MIL "ON" DTC P2111 and/or P0A0F After Cold Soak

YEAR(S)	MODEL(S)	ADDITIONAL INFORMATION
2010 – 2015	RX450H

Some 2010 – 2015 model year RX 450h vehicles may exhibit a condition of MIL "ON" with DTC(s) P2111 and/or P0A0F after a cold soak. Follow the Repair Procedure in this bulletin to address this condition.

Figure 1. Location of Authorized Modifications Label on 2010 – 2015 RX 450h

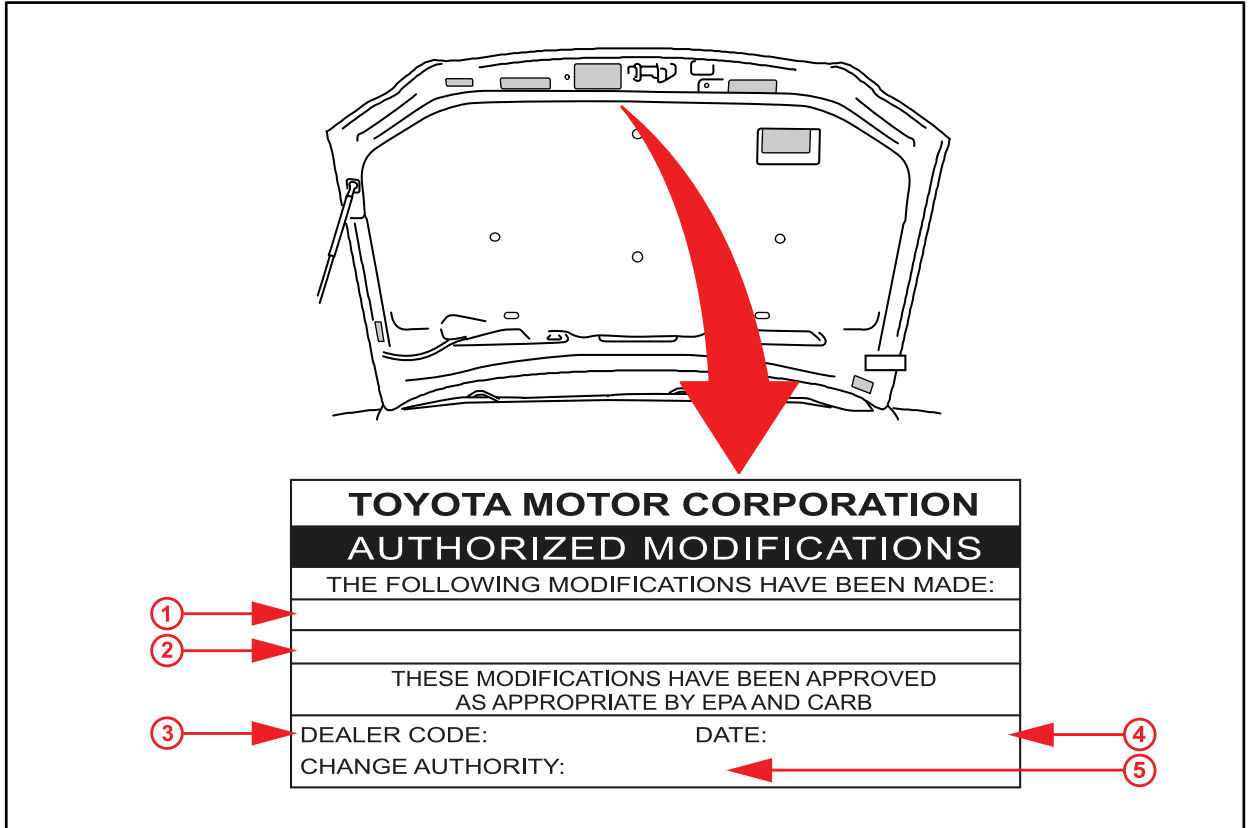
4. Check for the Authorized Modifications Label affixed to the vehicle in the location shown in Figure 1. Confirm if the ECM (PCM) calibrations have been updated. If the calibration IDs are NOT the latest calibrations — go to step 5.

- Start the engine and warm it up to normal operating temperature before test driving.
- Test drive the vehicle to confirm proper vehicle operation (and proper laser cruise control operation, if equipped).
- Install the Authorized Modifications Label.
 - Using a permanent marker, enter the following information on the label:
 - ECM part number [*Refer to the **Parts Information** section for the **NEW PART NUMBER***]
 - Calibration ID(s) [*Refer to the **Calibration Information** section for the **NEW CALIBRATION ID***]
 - Dealer Code
 - Repair Date
 - Change Authority [***This bulletin number***]
 - Affix the Authorized Modifications Label to the vehicle at the location shown in Figure 1. The Authorized Modifications Label is available through the MDC, P/N 00451-00001-LBL.
- Calibration update is complete.
